Retail Proposed Procedure Change (PPC) – Zonal Heating Value

Ref# (if applicable)	Package 3A IN007-22.		
Impacted jurisdiction(s)	Victoria		
Proponent	Danny McGowan	Company	AEMO
Proponent email	grcf@aemo.com.au		
Affected Gas Market(s)	Victorian Retail Market and Declared Wholesale Gas Market (DWGM)		
Date proposal published by AEMO	15 September 2023	Date proposal sent to AEMO	1 March 2022
Short issue title	Modifications to the way AEMO determines Victorian heating value zones and the heating value information that AEMO will make available for basic metering energy calculation.		
Procedure(s) or Documentation impacted	Retail Market Procedures (Victoria)		
Other key contact information

Version #	Presented to	Date
1.0	GRCF	15 September 2023

Attachment F – Participant Build Pack 1. Table of Transactions changes.

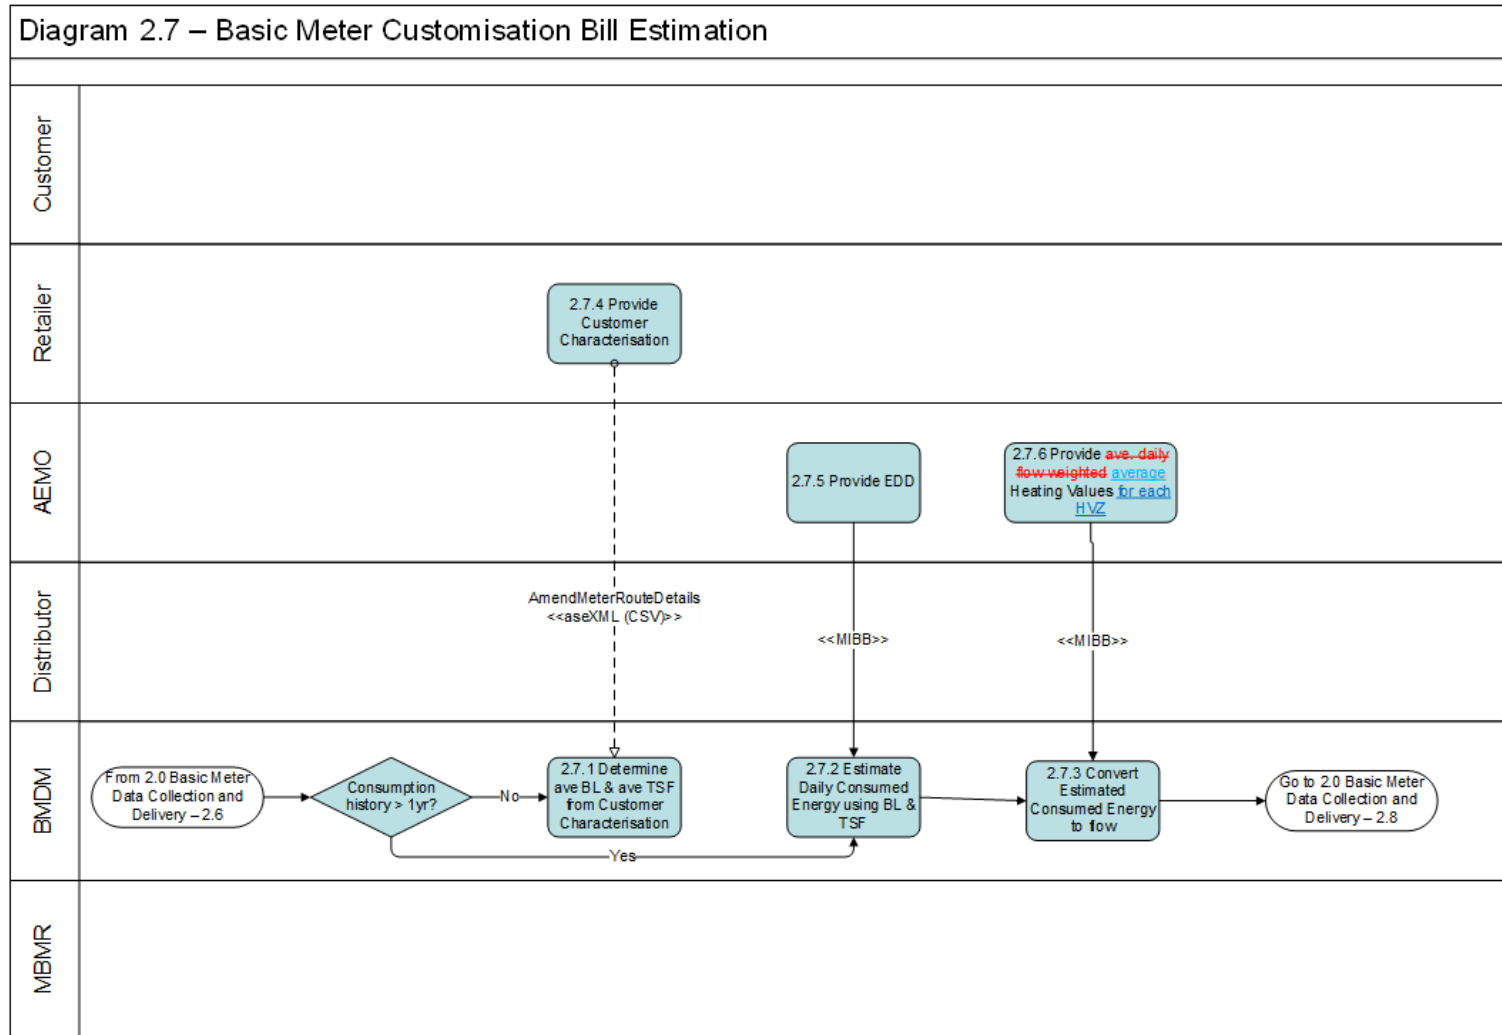
Draft versions of the Technical Protocol (extract) showing tracked changes between the current version and the proposed changes are shown below. [Blue underline](#) means addition and ~~red strikeout~~ means delete.
